## Technical Bulletin

Ref: **TB-16018-ENG**

Affected parts: Injector Module

Subject: **Updated Injector Module (PN 90849)**

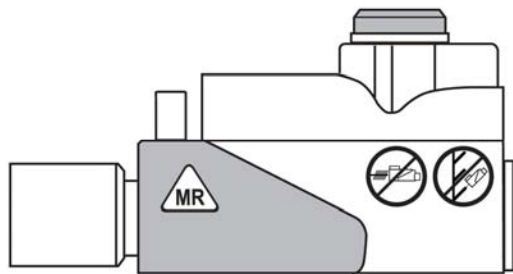
Mallinckrodt is introducing an updated injector module that has equivalent performance to the current injector modules (PN's 1605-3038-000, 90726 and 90713) along with improved appearance and ergonomics (see below). This new injector module is qualified to be used with all models of INOmax DS<sub>IR</sub> delivery systems only.

Mallinckrodt will not proactively replace the original box style injector module. The new-style injector module will be phased in over time. Continue to use whichever style injector module is provided with your device, as both styles are functionally equivalent.

**Injector Module Side View (PN 90849)**

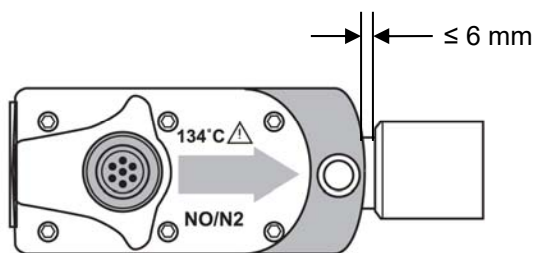
The internal passages and taper specifications are the same as the previous injector modules with the following exception:

The external dimensions of the new injector module complies with ISO Standard 5356-1, Anaesthetic and respiratory equipment; Conical connectors; Part 1: Cones and sockets, with the exception of clause 3.2.1, which requires relief of  $\geq 6$  mm on connection tapers to accommodate a breathing tube equipped with a latching socket. The top view below shows where the exception is located on the updated injector module.

**Caution: Breathing circuit latching sockets may not fully engage the injector module (PN 90849) outlet, when connecting to the outside taper.**
